V2500-A1 SERIES PROPULSION SYSTEM SERVICE BULLETIN

This document transmits the Revision 4 of Service Bulletin V2500-ENG-75-0001.

AIR – INTRODUCE A REVISED LPT ACC SUPPORT ASSEMBLY CONFIGURATION**1. Planning Information****A. Effectivity**

Location of LP Turbine Support Assemblies
Fig.1

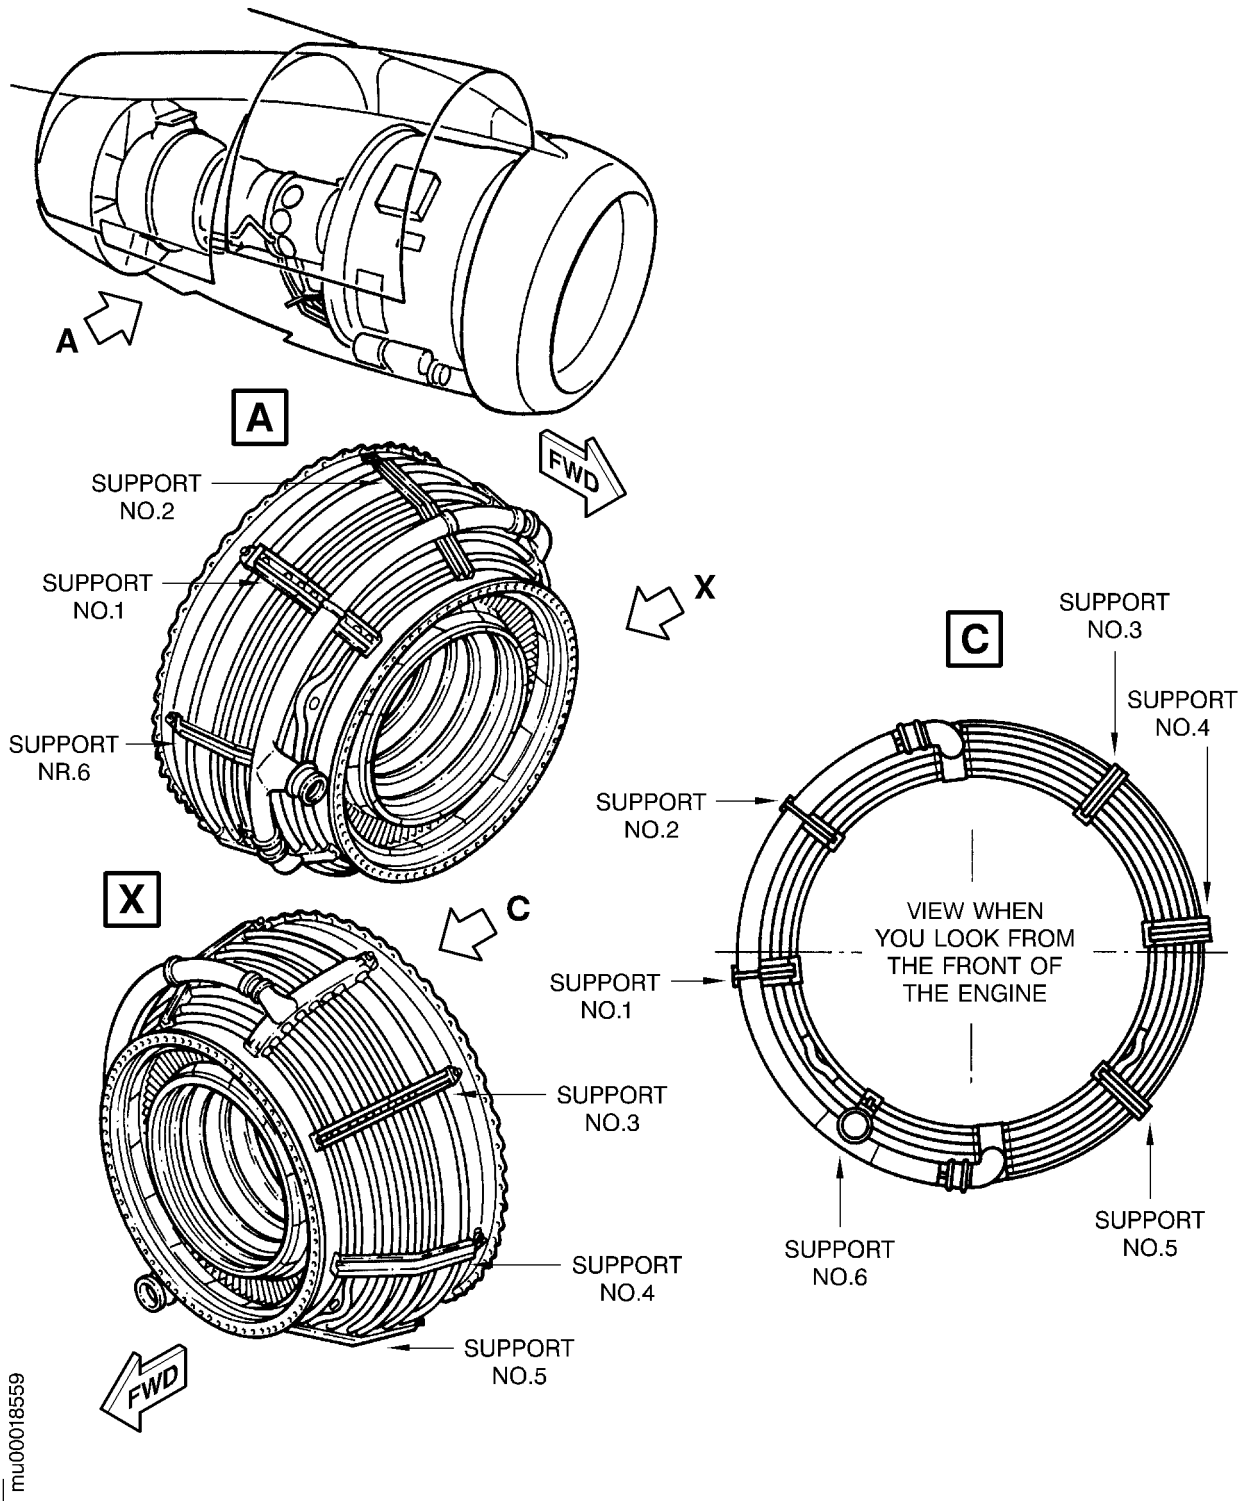
The supports A/O and half loop clamps are preassembled with rivets at the front and rear ends.

Clip nuts are attached to the half loop clamps.

The supports have clip nuts at the front LP Turbine case attaching location.
